FSCA Ref: 656504 & 661861

Urgent Field Safety Notice HLS Set 7050 & HLS Set 5050

Urgent Field Safety Notice (FSN) HLS Set 7050 & HLS Set 5050 Risk addressed by FSN

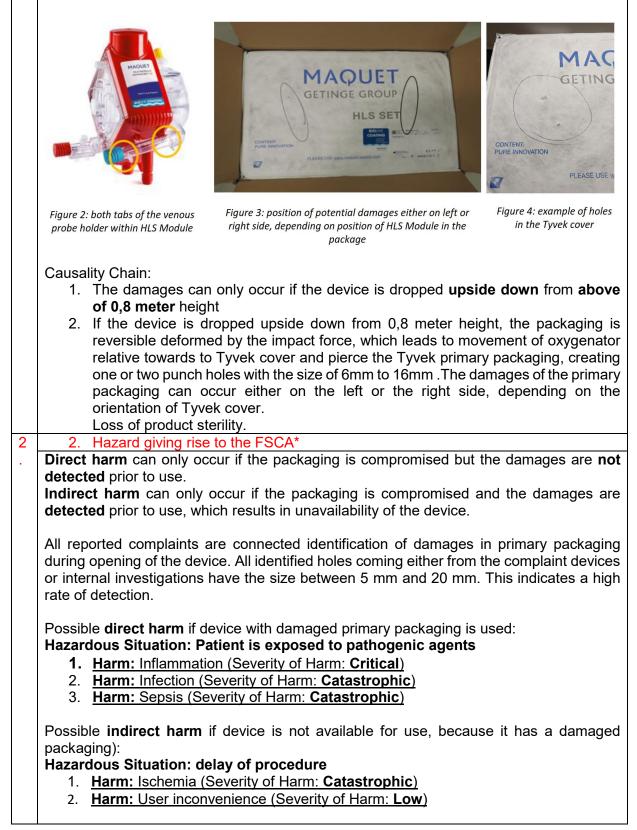
2 Reason for Field Safety Corrective Action (FSCA)*		
1	2	 Description of the product problem* 	
		The HLS Set Advanced is intended for use in an extracorporeal circulation for cardiac support and/ or pulmonary support. Maquet Cardiopulmonary GmbH (MCP) has received customer complaints of damage to the primary packaging of the HLS Set Advanced.	
		In all customer complaints it was reported that the Tyvek cover was damaged. The appearance of the packaging failure can be hole(s) in the Tyvek.

The damages are caused by the tabs of the venous probe holder within the packaging (figure 2). Consequently, depending on the orientation of the Tyvek cover on HLS tray, holes can appear either on the left or right side of the Tyvek (figure 3 and 4), which corresponds to the position of the venous probe holder.

3. Type of Action to mitigate the risk*
3.	1. Action To Be Taken by the User*
	□ Identify Device □ Quarantine Device ⊠ Return Device □ Destroy Device
	⊠ On-site device modification/inspection
	Follow patient management recommendations
	□ Take note of amendment/reinforcement of Instructions For Use (IFU)
	□ Other □ None
	Actions to be taken by Customer Due to a potential delay of replacement products, the user can choose between two options:
	Option 1 (Return Device) 1. Please return immediately all affected products in your stock to your local Getinge representative.
	In case of return of the affected products, please contact your local Getinge representative for credit or replacement.

3. If a product is already in use, it should remain in use.
	Option 2 (on-site device inspection) : If the products are necessary based on expert clinical judgement, you can use the devices after following these inspection measures:
	 Prior to use, the HLS Sets Tray covers have to be checked visually for any damages, holes or tears in order to prevent the use of an unsterile medical device. After removing the tray from the secondary package (white cardboard box), position the tray in a well-lit area outside the sterile field.

3. Check the integrity of the sterile barrier of the tray (Tyvek cover) before use. If any doubt arises as to package integrity, then it should not be used. Any product with damaged packaging must be returned to the local Getinge representative.
	 Please note, that all products which you can receive at this time contains old packaging design and they have affixed "Inspection instruction" on the white box.
	Regardless of the decision you make, please complete and sign the attached customer response form and send it back to your local Getinge representative.
	Please report any adverse events in regards to the affected products to your Getinge Representative.
	Transmission of the Field Safety Notice:
